Subject: Proposed Revised Remediation Plan in Response to May 1, 2025 LEA Letter

CHIQUITA CANYON CASTAC, CALIFORNIA

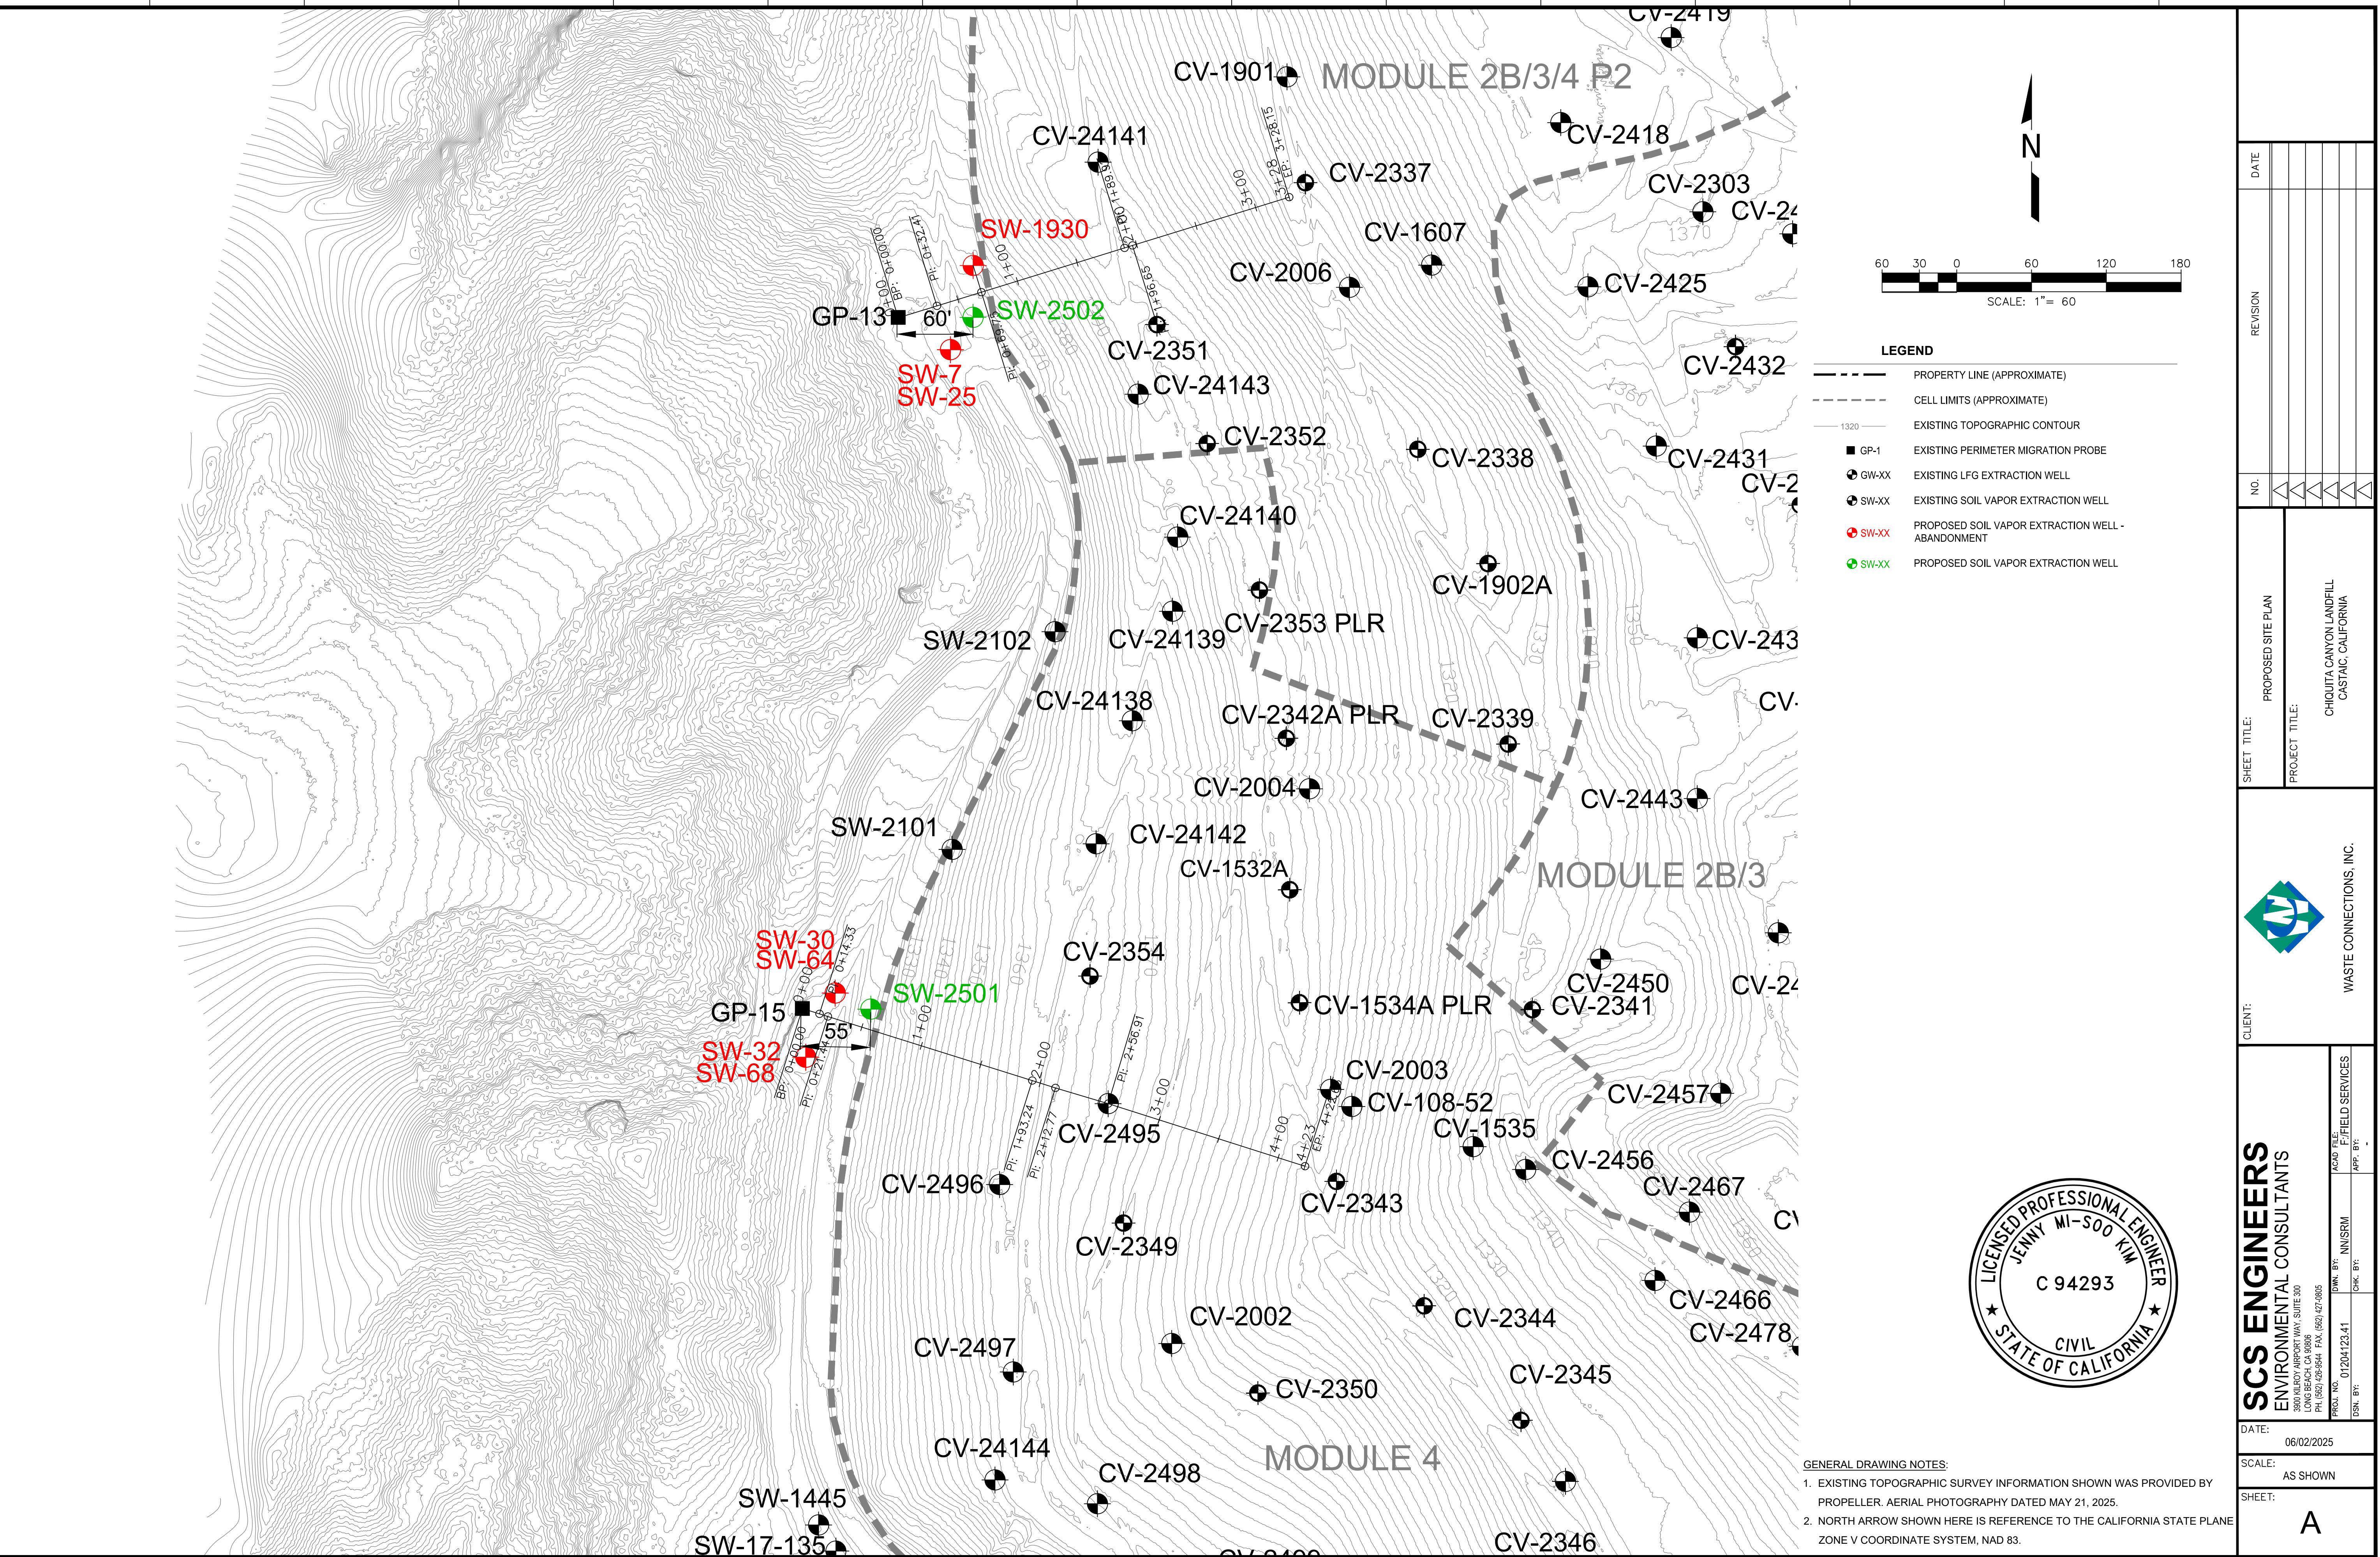
Item 2: Provide a map showing the locations and design details for the proposed new soil vapor extraction (SVE) wells to the LEA for review and approval prior to installation. CCL shall ensure that the perimeter monitoring wells are not located within the radius of influence from the SVE wells to prevent the monitoring results from being affected. Please see the

A map of the approximate locations of the proposed new soil vapor extraction (SVE) wells is included in **Attachment A**. The exact radius of influence of the new SVE wells cannot be calculated due to unknowns in the exact geological strata that will be encountered during drilling. As shown in Attachment A, the new SVE wells will be positioned further away from the existing probes and closer to the waste than the existing SVE wells, thereby reducing the possibility of influence on the perimeter monitoring probes from what is currently installed. Additionally, in order to comply with Title 27 CCR, the perimeter monitoring probes are within 100 feet of the edge of waste; because of this, the maximum possible distance between the monitoring probes and the SVE wells is limited. Upon further consideration of these details as well as CalRecycle's comments, the maximum number of SVEs possible is limited to two (2) locations, each with two SVEs positioned at different depths within the same borehole, for a total of four (4) SVEs. This number of wells is sufficient to collect the LFG migration prior to the compliance boundary. A drawing showing the distance between the edge of waste, monitoring probes, existing SVE wells, and proposed new SVE wells is provided in Attachment A.
